ADDENDUM 1
TO
SPECIFICATIONS, BID AND CONTRACT DOCUMENTS

1st Street SE Revitalization

CITY OF Paris, TX

MTG NO. 246035

NORTH VAULT PLANS & SECTIONS

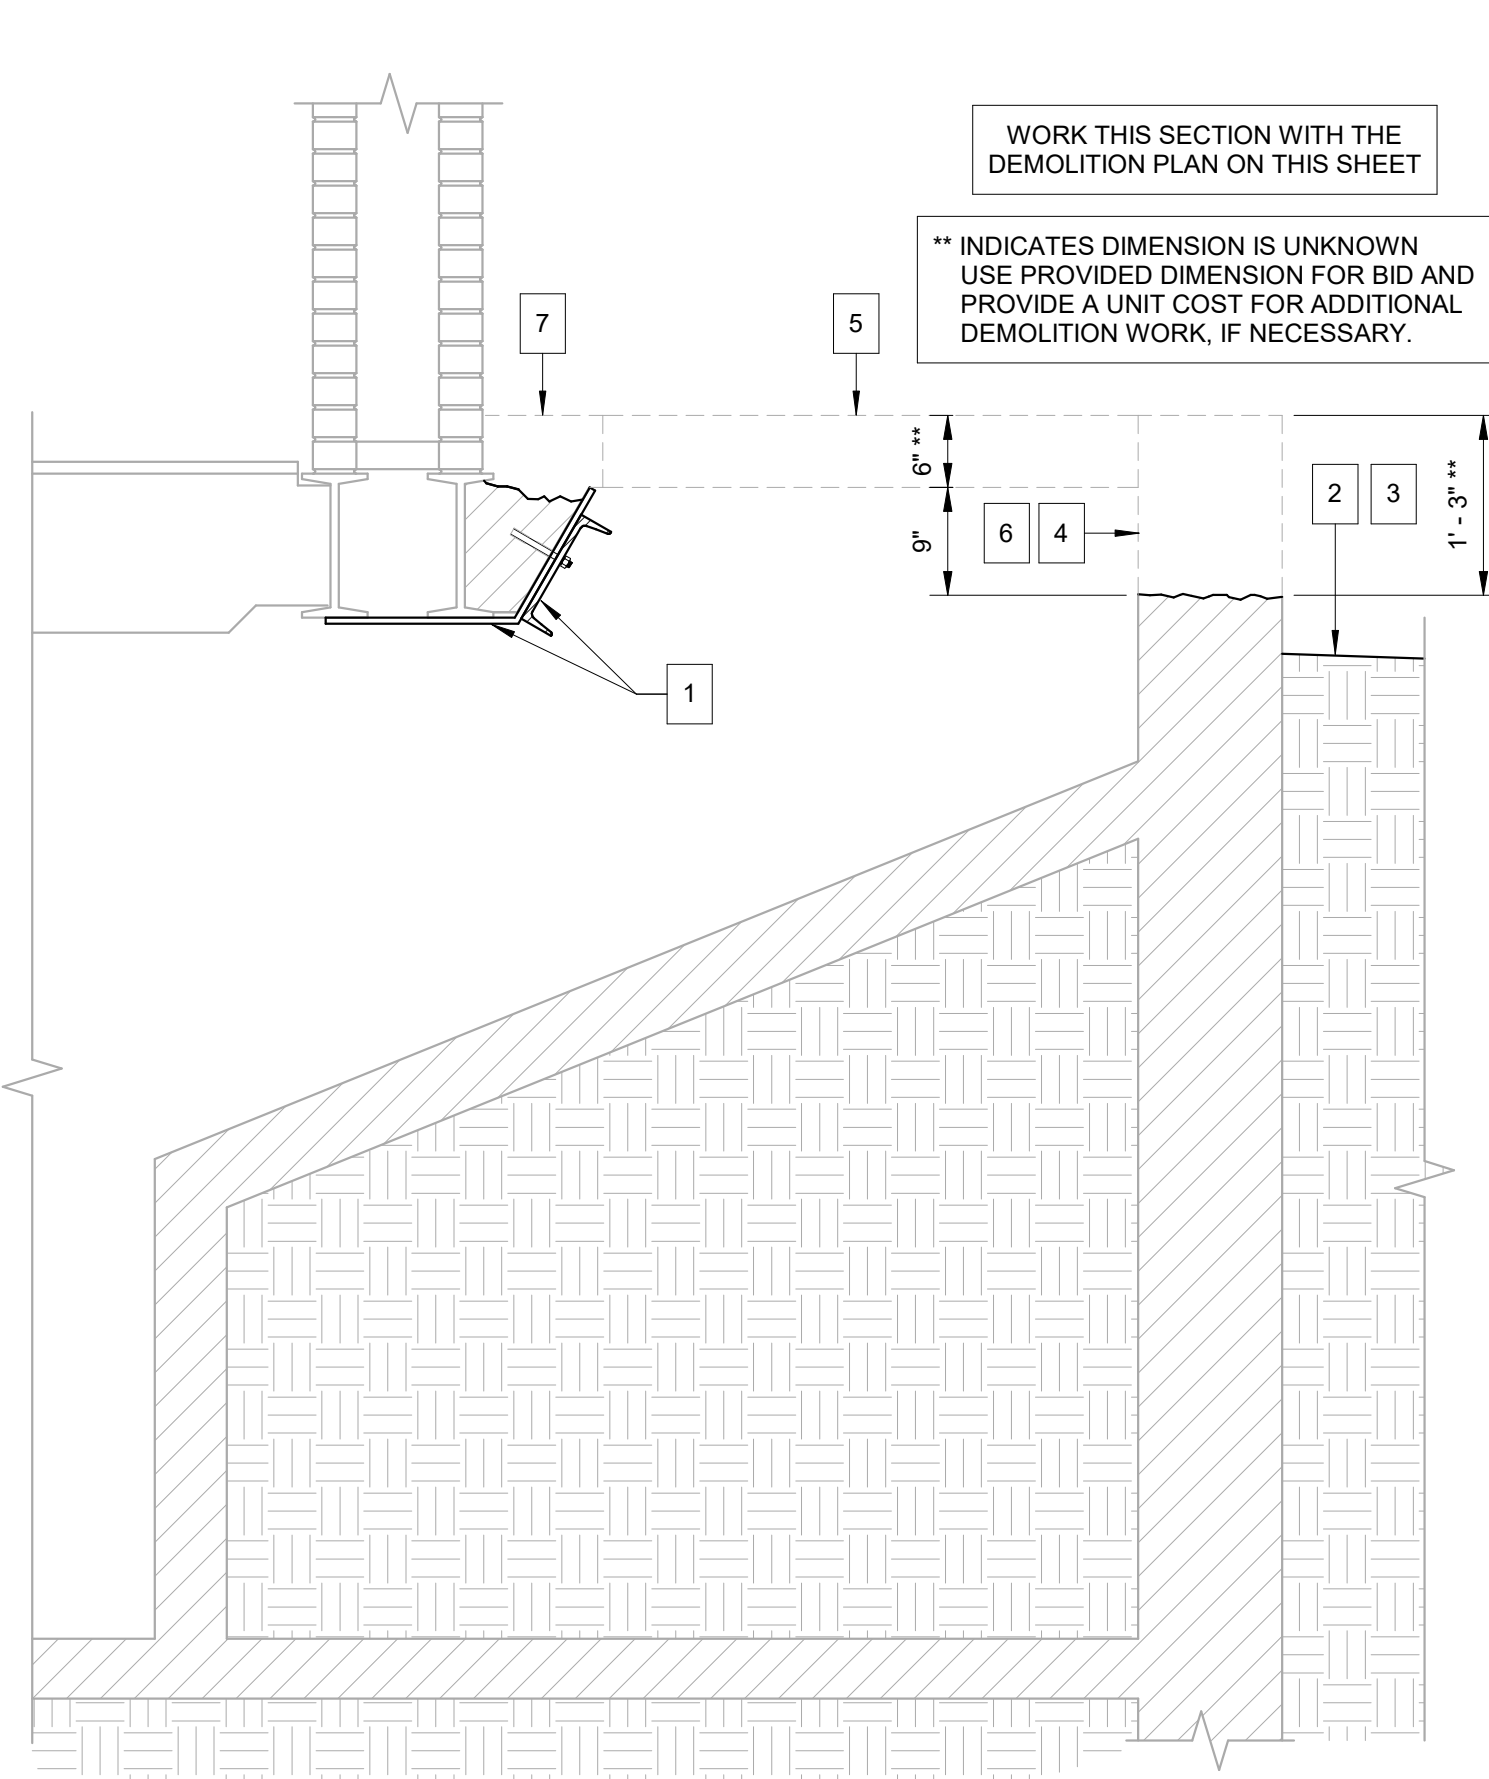
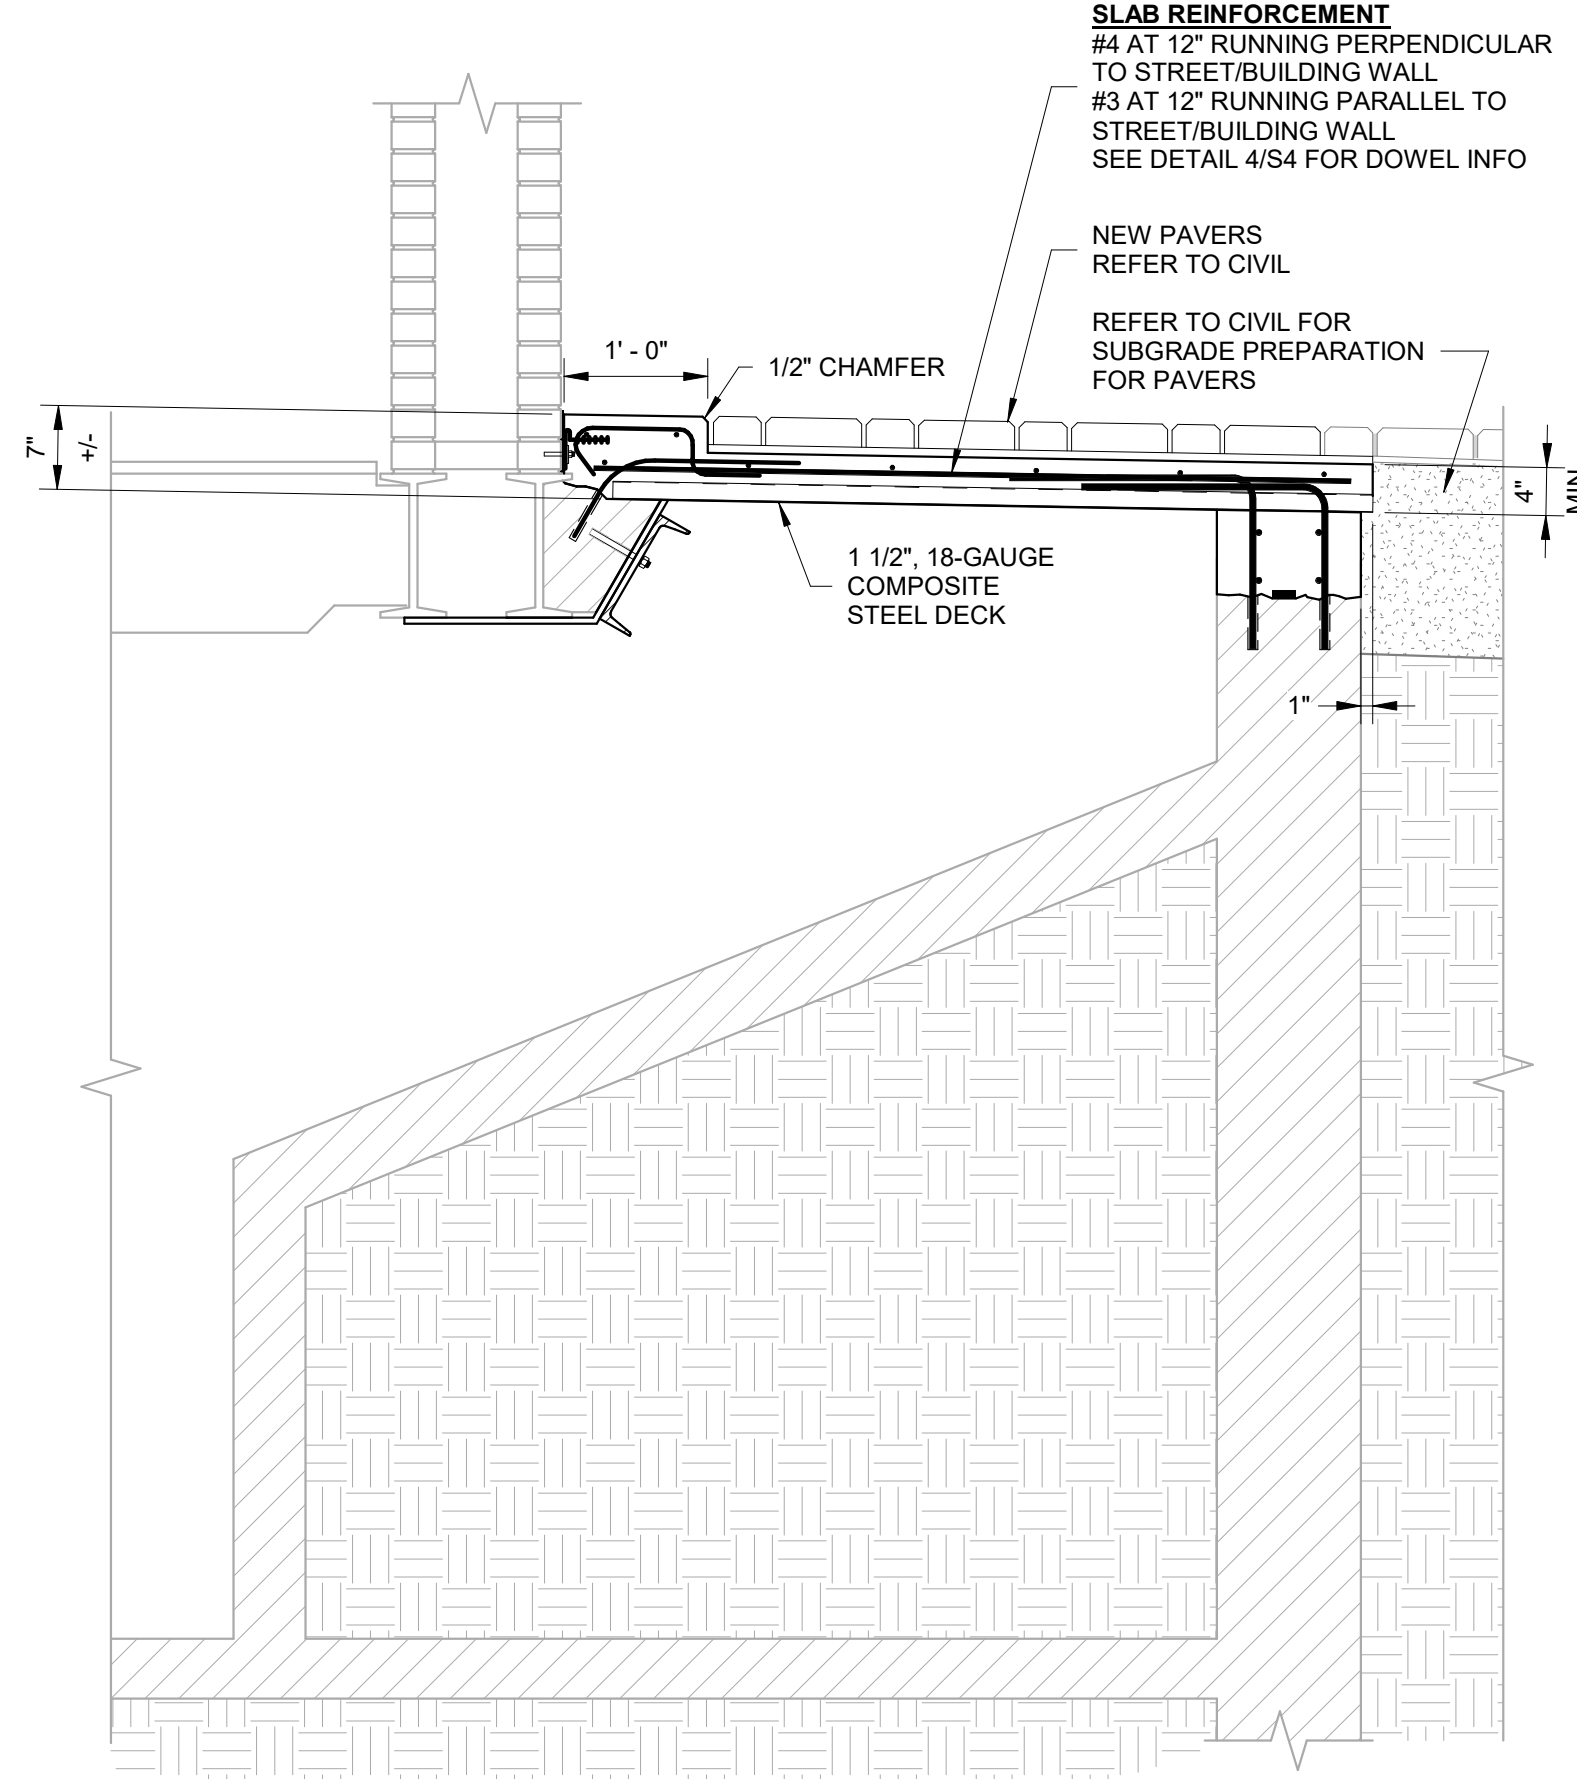
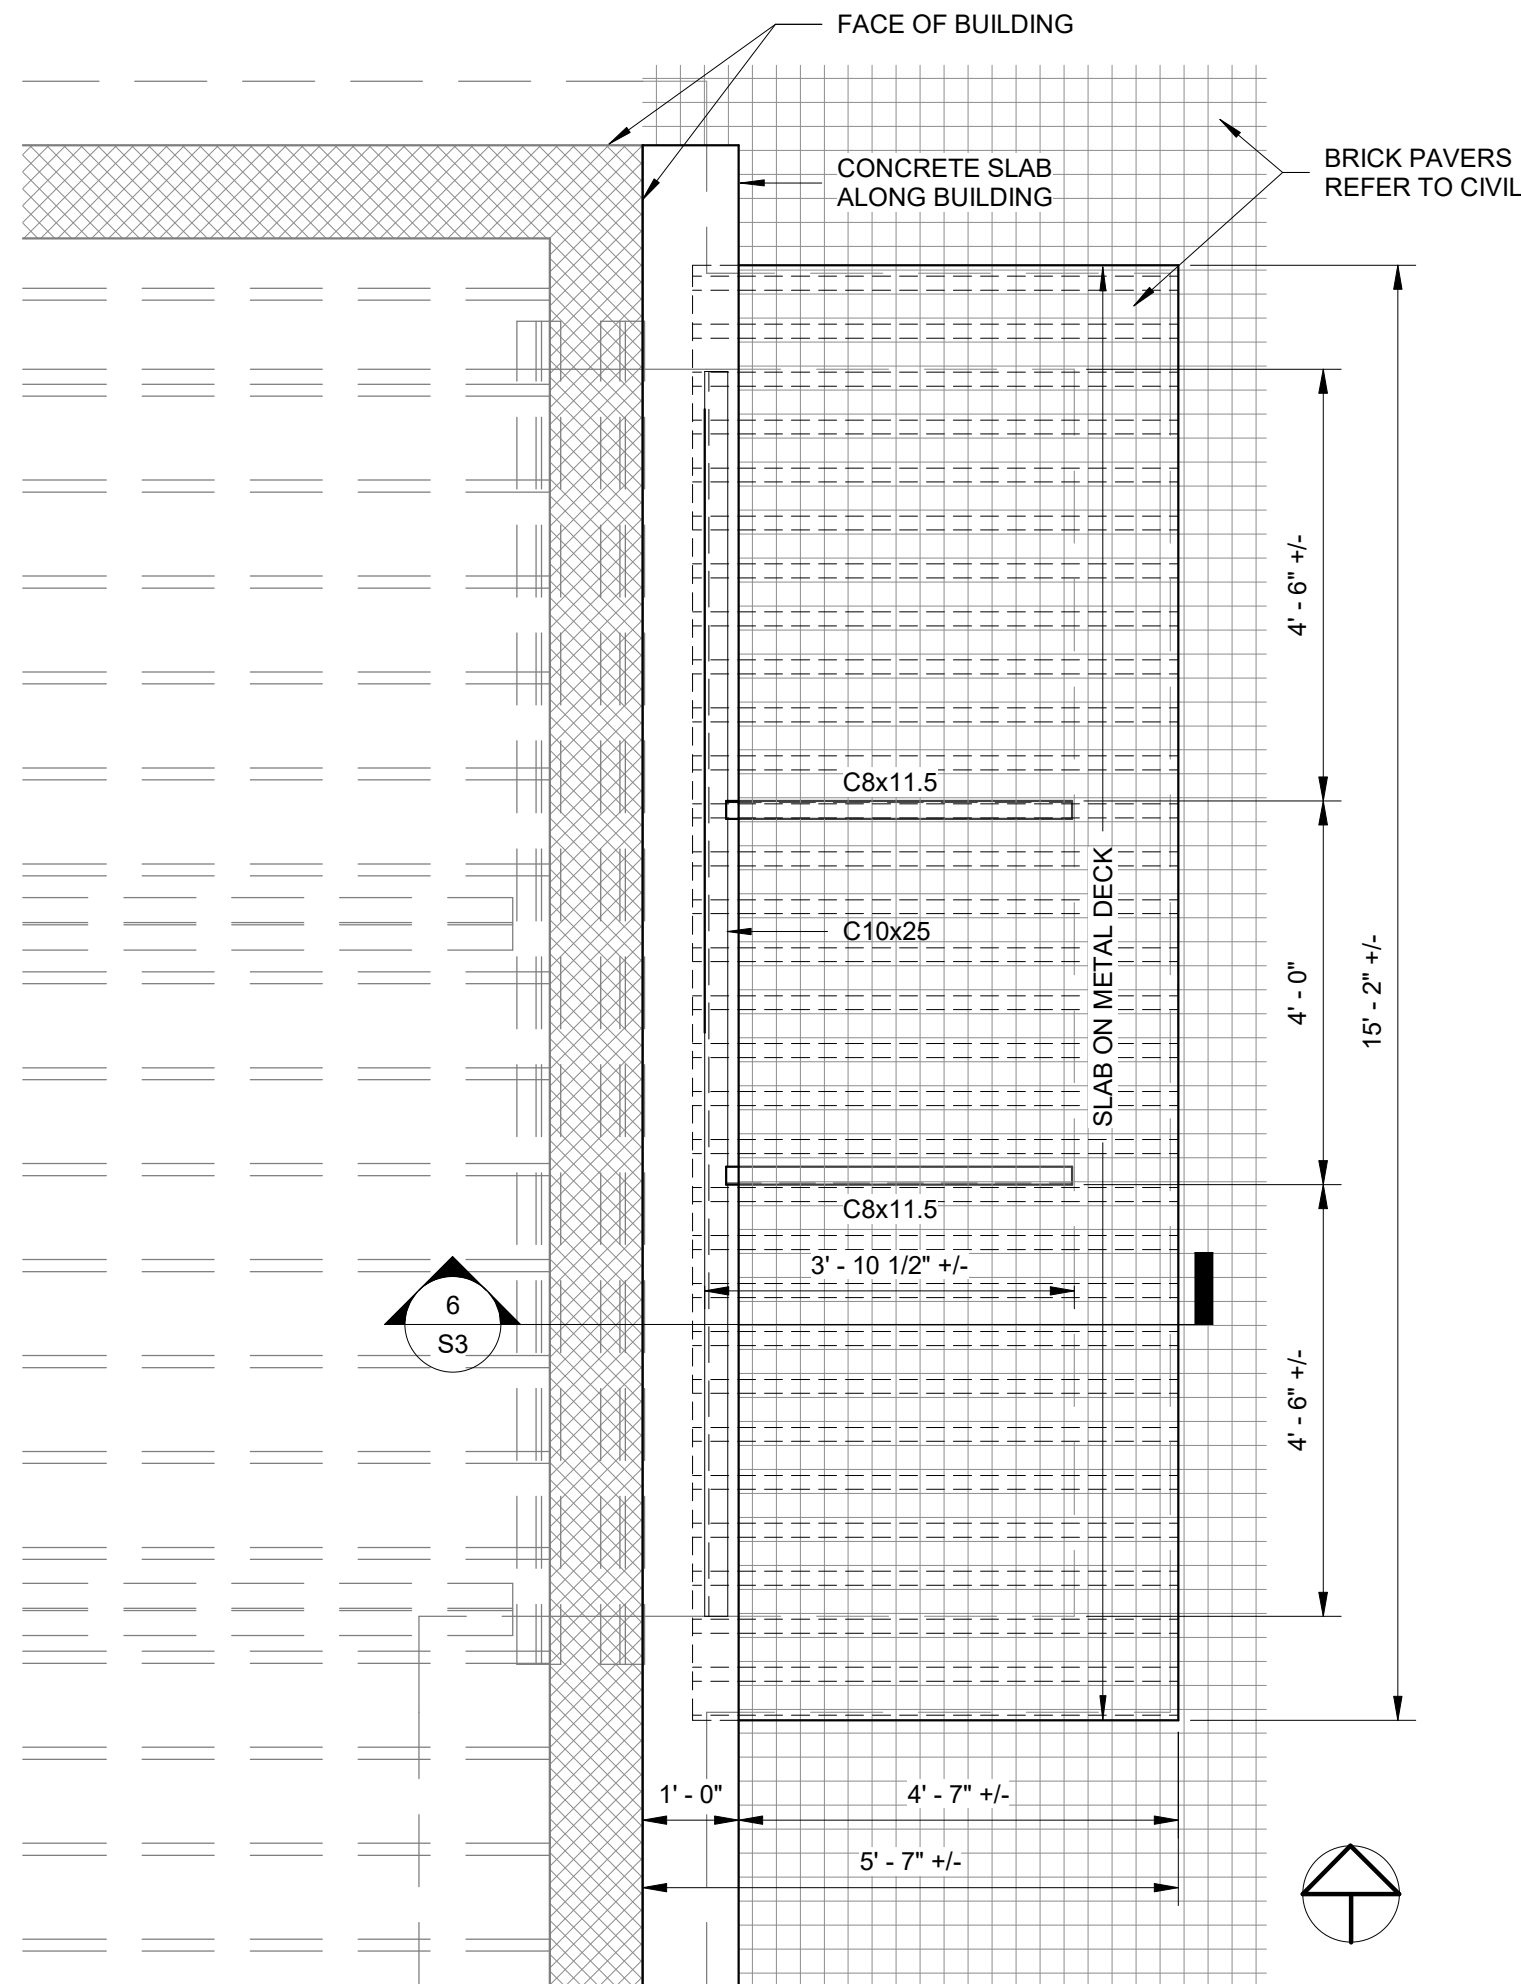
AD-1.5 Plan sheets S1,S2,S3: Plans have been replaced with corrected documents and S4 has been added to clarify Material Type and Thickness. Please replace the previous Plan Sheet S1, S2, & S3 with the attached Plan Sheet S1, S2, S3, & S4.

- C1.3: Item 12: Structural Brick Paving: Description revised, this bid item includes all work shown on sheet S1,S2, & S3 for the two (2) Structural Vault Caps. Brick Paver Furnish and install not included in this Lump Sum Item**
